APPLICATION ON NOTIFICATION – CATEGORY 2

Applicant:	Walpol Development Pty Ltd C\ - Future Urban Group
Development Number:	211/M013/17
Nature of Development:	Demolish existing buildings on site, removal of one regulated tree and the construction of an 8 storey mixed use building comprising, 36 residential apartments, two levels of car parking and a cafe at ground floor
Type of development:	Merit
Zone / Policy Area:	Urban Corridor Zone / Boulevard Policy Area 34
Subject Land:	192 Anzac Highway, GLANDORE & portion (Right of Way) of 190 Anzac Highway, GLANDORE
Contact Officer:	Brett Miller
Phone Number:	8343 2988
Start Date:	19 January 2018
Close Date:	5 February 2018

**RESPONSE TO REQUEST FOR FURTHER INFORMATION AND REFERRAL COMMENTS FOR
192 ANZAC HIGHWAY, GLANDORE (DA 211/M013/17)**

Figure 1 – Turning path diagram for a 7.4 metre waste collection vehicle (prepared by GTA Traffic Consultants).

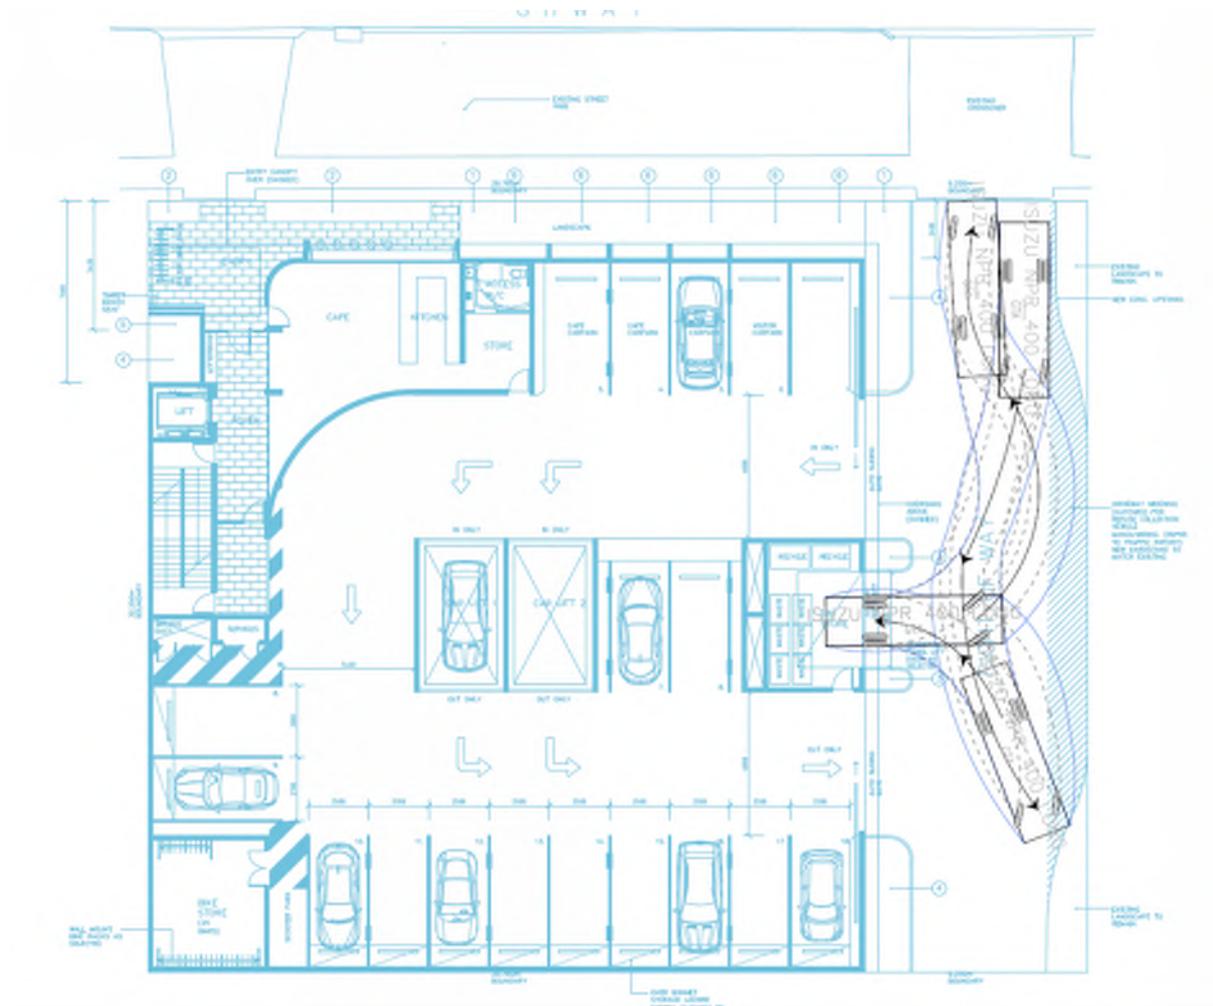
- the one-way flow of traffic through the car parking area should be reversed to reduce the likelihood of queues forming along Anzac Highway;
- waste loading should be amended to be provided within the development to allow service vehicles to stand wholly within the site, whilst enabling simultaneous two-way traffic within the Right of Way;
- confirmation in the form of turn path diagrams to show that the largest vehicle proposed to access the subject site will be able to enter and exit in a forward direction; and
- any vegetation will be low in height, and maintain adequate driver and pedestrian sight lines.

The largest vehicle proposed to access the subject site will be a 7.4 metre waste vehicle. The turning diagrams for this vehicle were provided in Figure 6.1 of the GTA Transport Impact Assessment provided to DPTI (dated 24 May 2017). This diagram has been extracted from the report and included overleaf for clarity. It clearly shows that a waste collection vehicle of 7.4 metres in length will be able to access and exit the site in a forward direction.

Figure 2 – Turning path diagram showing the simultaneous entry/exit movement of vehicles (prepared by GTA Traffic Consultants).

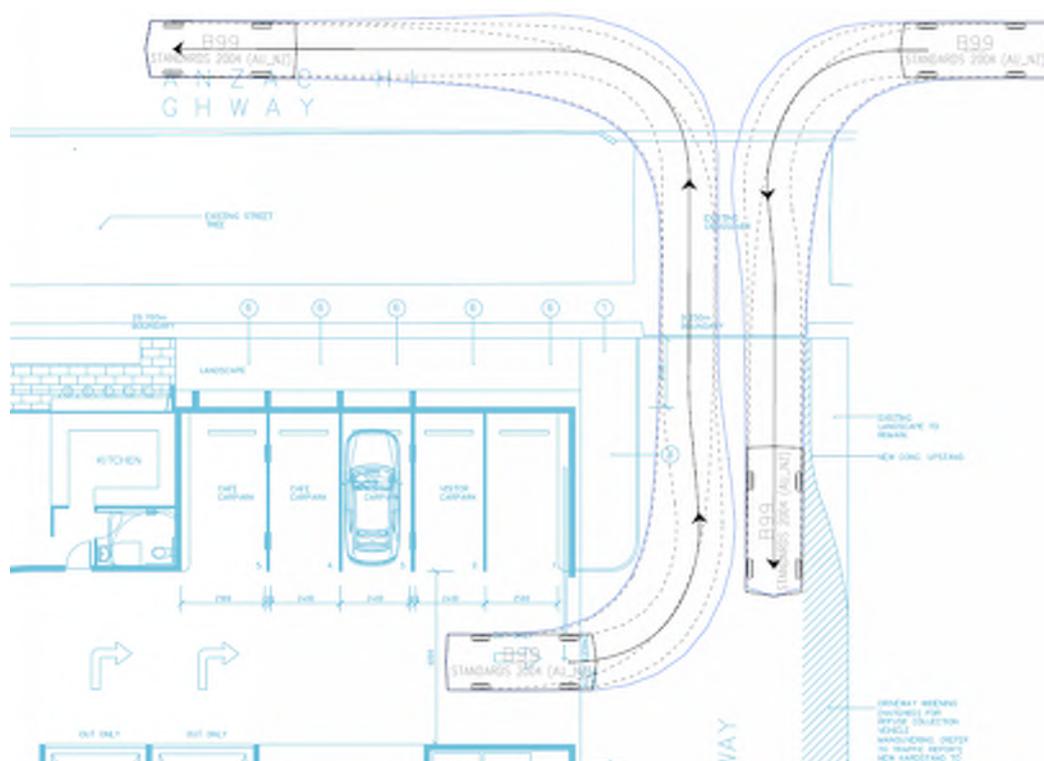
Council also suggested that the width of the crossover to Anzac Highway be increased to 6.0 metres from its current width of 5.95 metres. GTA have not considered this necessary in this instance, as the existing width of the driveway is only marginally less than that which is envisaged and importantly, the crossover will still be of sufficient width to allow the simultaneous entry/exit of two vehicles. A diagram showing this movement has been extracted from the GTA report, and is included below.

PROPOSED GROUND LEVEL FLOOR PLAN
1:100 @ A1, 1:200 @ A3

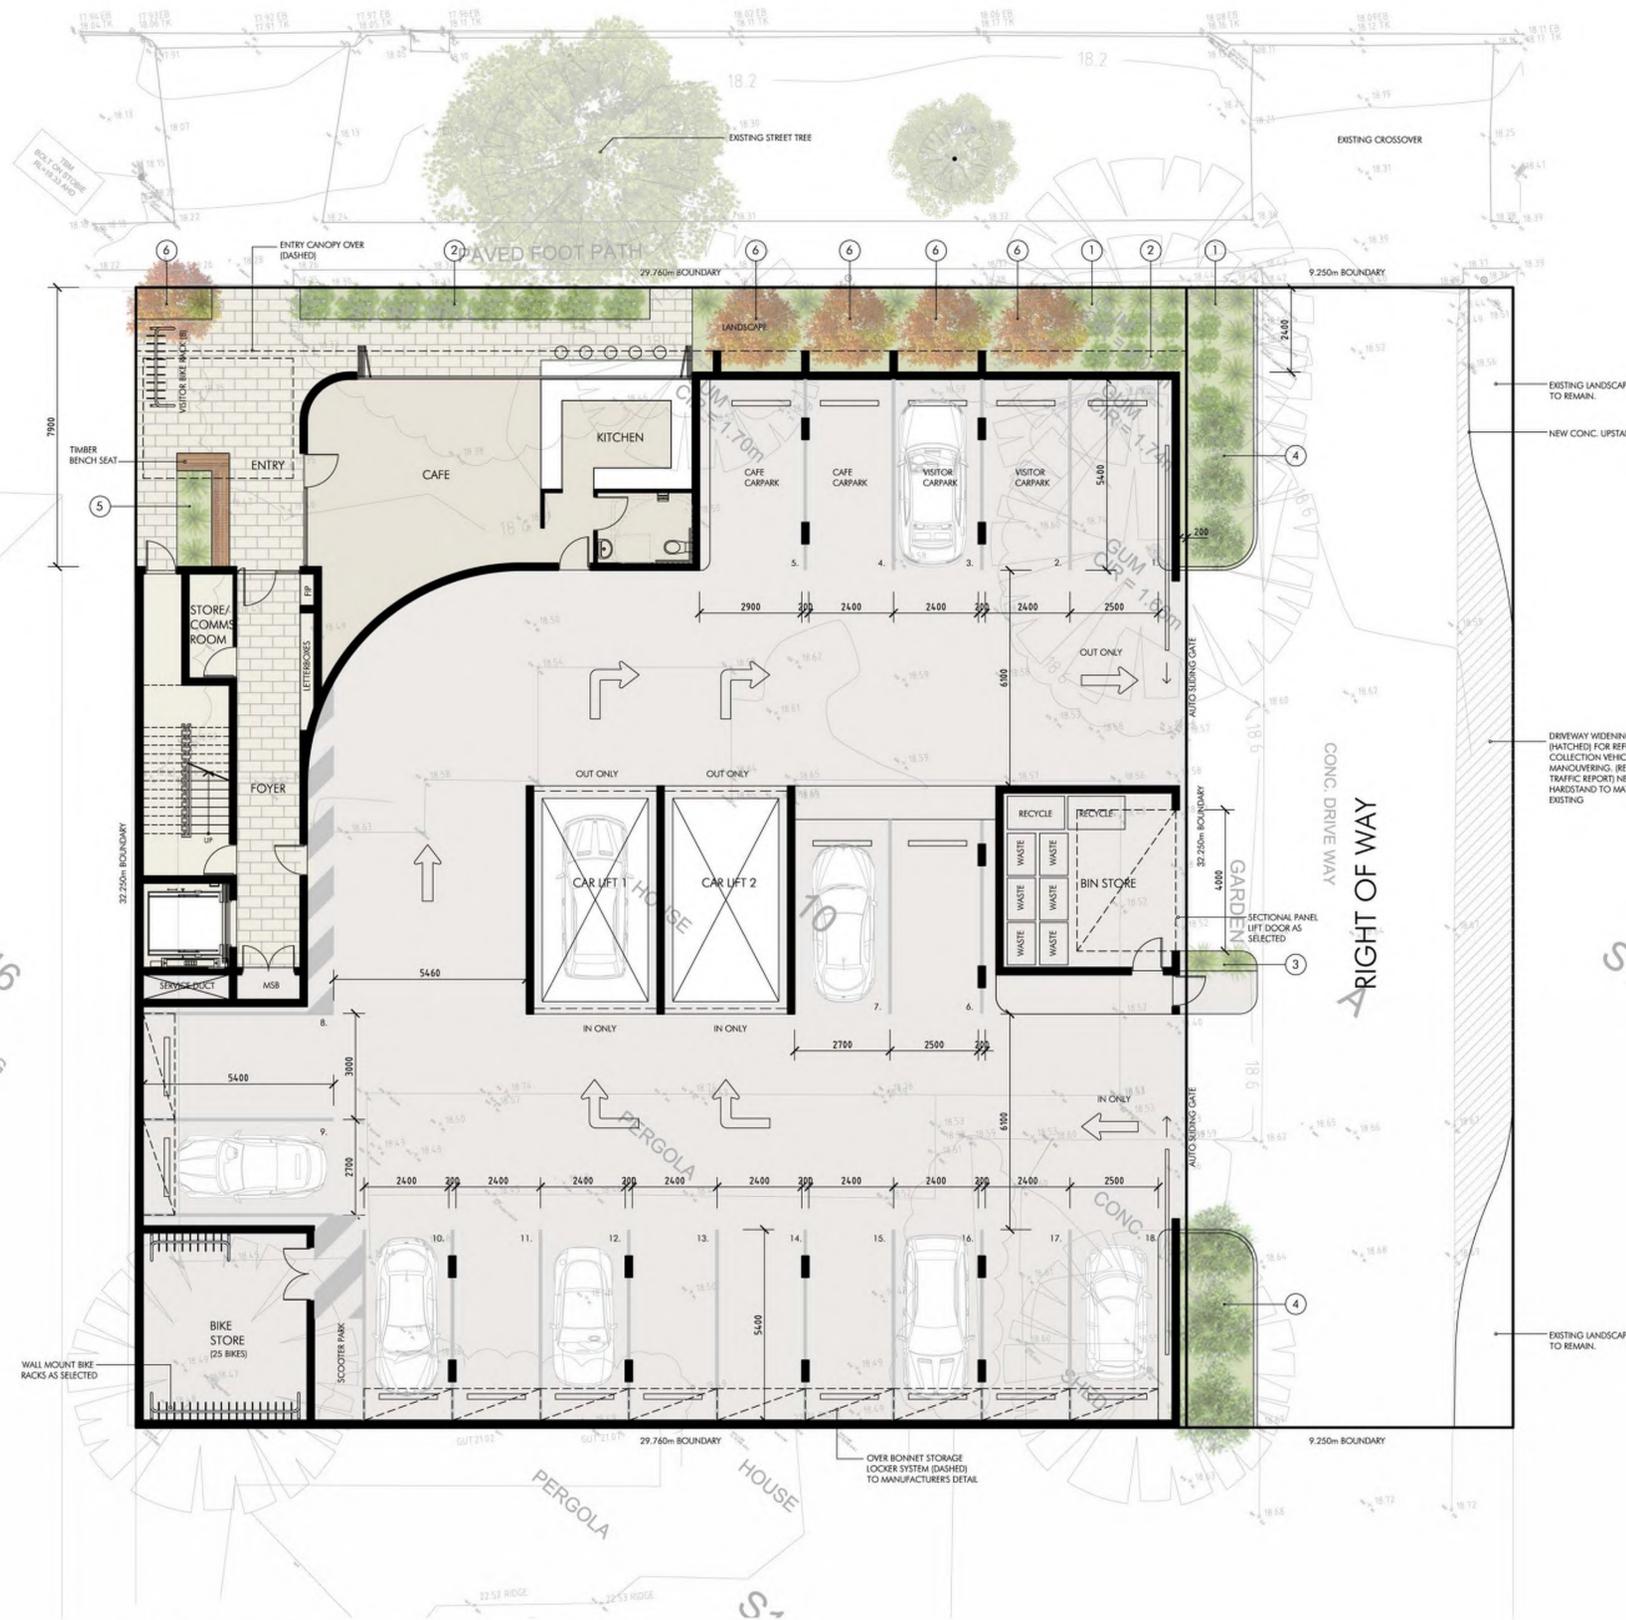
The landscaping proposed to be planted within close proximity to the crossover will be low-height shrubs such as “Lomandra Tanika” as indicated on the Ground Level floor plan prepared by Piteo Design Architects. These shrubs are anticipated to maintain adequate pedestrian and driver sightlines as noted by DPTI Traffic Operations.

ODASA identified that the Ground Level floor to ceiling height of 3 metres is significantly less than the 4.5 metre minimum ground level height envisaged by the Development Plan. The floor to ceiling height at Ground Level has been increased to the envisaged height which resolves this concern.

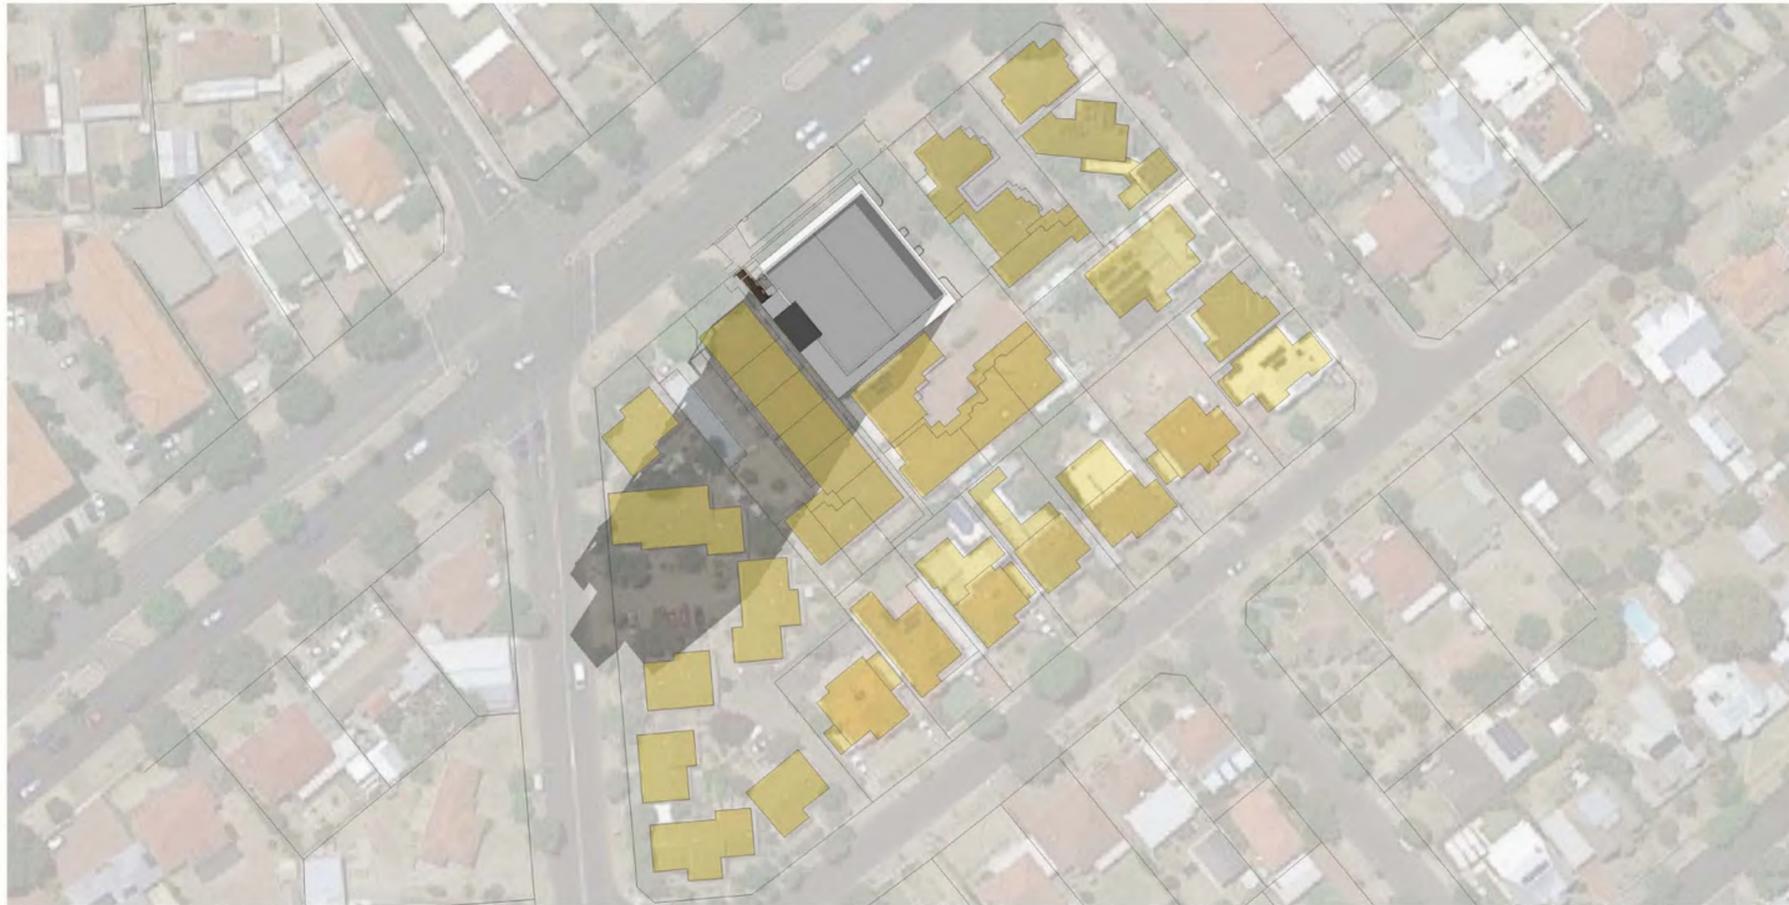
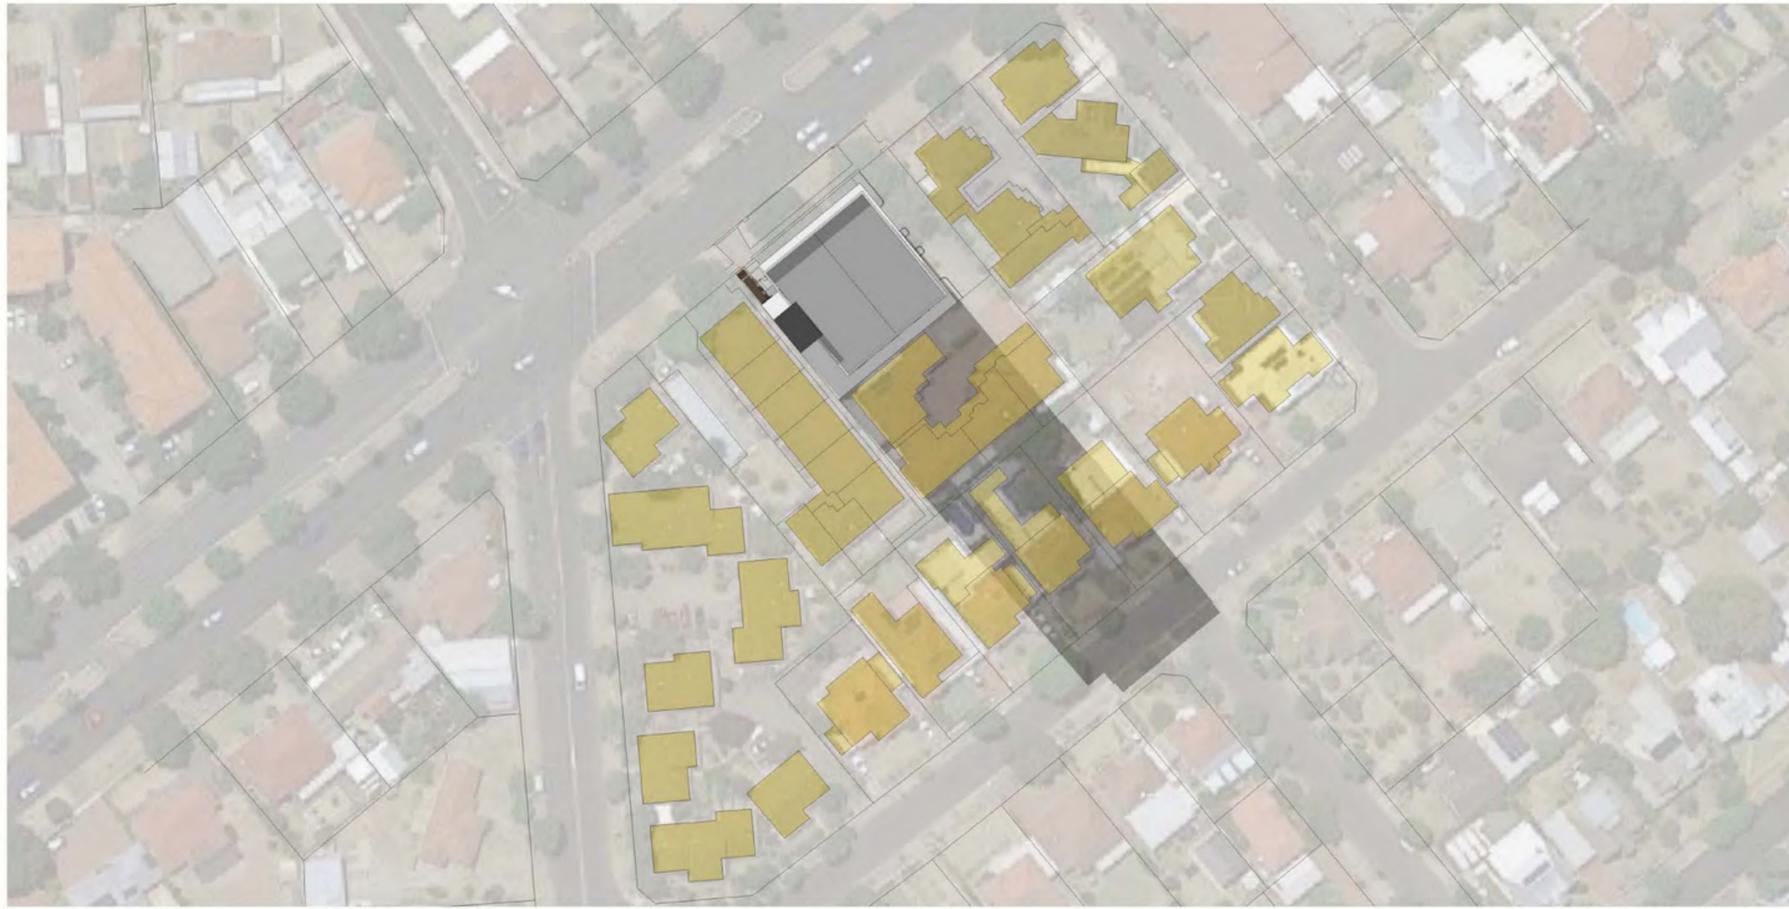
1. Revised shadow diagrams at a larger scale than those originally provided, including the adjoining building footprints, private yards and allotment boundaries to clearly depict the extent and potential impact of shadow cast from the proposed development;

Further, it is also noted that setting back the lift core and stairs 3 metres will result in a negligible change to overshadowing.

Figure 1: B99 Simultaneous Movements at Site Access

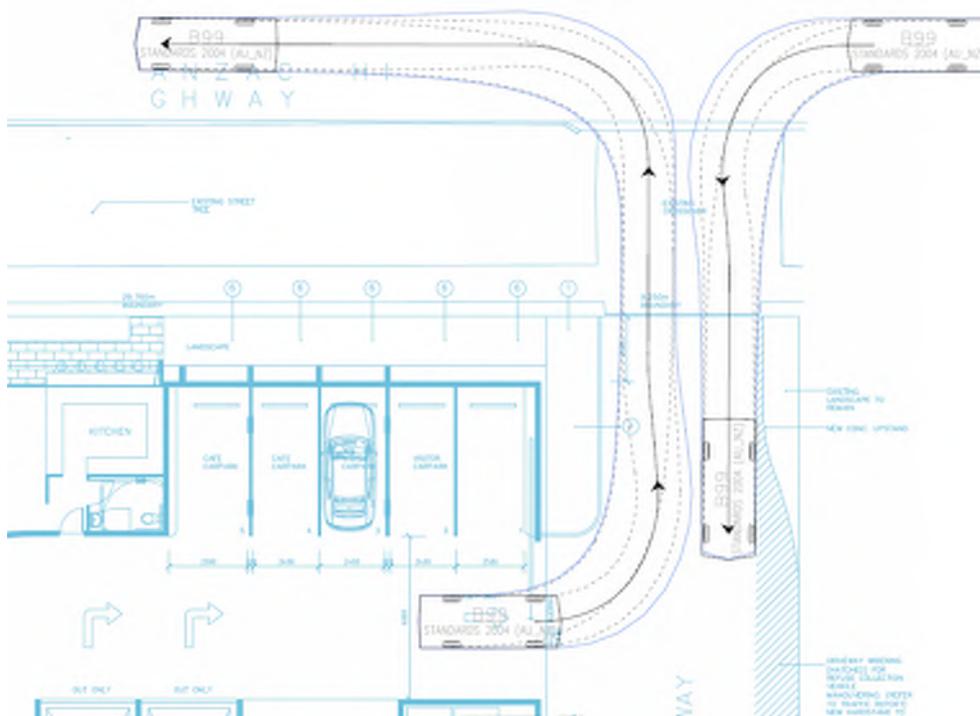
The proposed site access is identified as 5.95m wide between the existing walls. GTA acknowledges that a width of 6m is identified within the relevant Australian Standard for an access on to an arterial road serving more than 25 car parks.

However, it can be demonstrated that two vehicles can pass simultaneously through the existing access and this is shown in Figure 1.
